# Office Action Summary

10/680,269

DEMBICKS, TYLER J.

### DETAILED ACTION

## FIG. 6

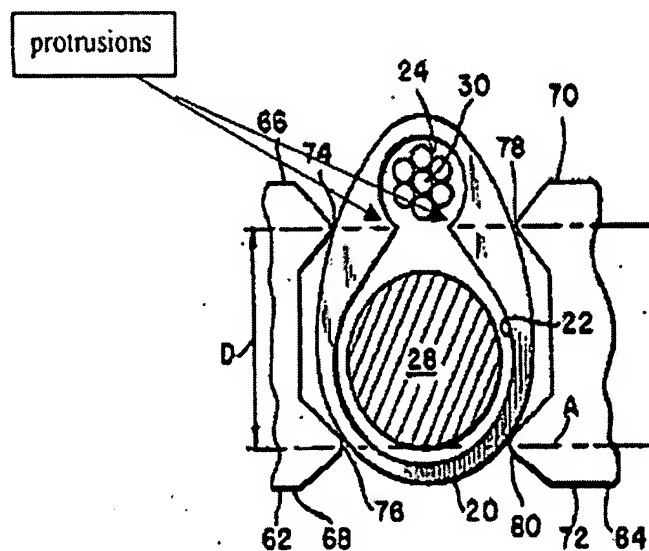
Claims 1-3, 5, 12, 15, 16, 18, 25, 27-29, 33, and 34, are rejected under 35 U.S.C. 102(b) as being anticipated by Luongo (U. S. Patent No. 3,916,517). Luongo ('517) discloses a crimp (see Fig. 1-7, Fig. 6 provided herein), comprising: a body (20)

having at least one fishing line receiving cavity (24, 96, is capable of being a fishing line receiving cavity) extending through the body and adapted to receive at least two diameters of a fishing line; and at least one pin cavity (22, 94 is capable of receiving a pin) adapted to receive at least one pin (28), the at least one pin (28) extending from the body;

(concerning claims 2, 15, 27 and 28) the at least one line cavity extending through the body is formed from two opposing sidewalls (48, 50, or sidewall portions having crimp detents 94, 96) shaped to receive two diameters of a fishing line having a substantially cylindrical cross-section;

(concerning claims 3, 16 and 29) each of the two opposing sidewalls comprise at least one protrusion (see Fig. 6 above) for positioning a generally cylindrical fishing line in the at least one fishing line receiving cavity;
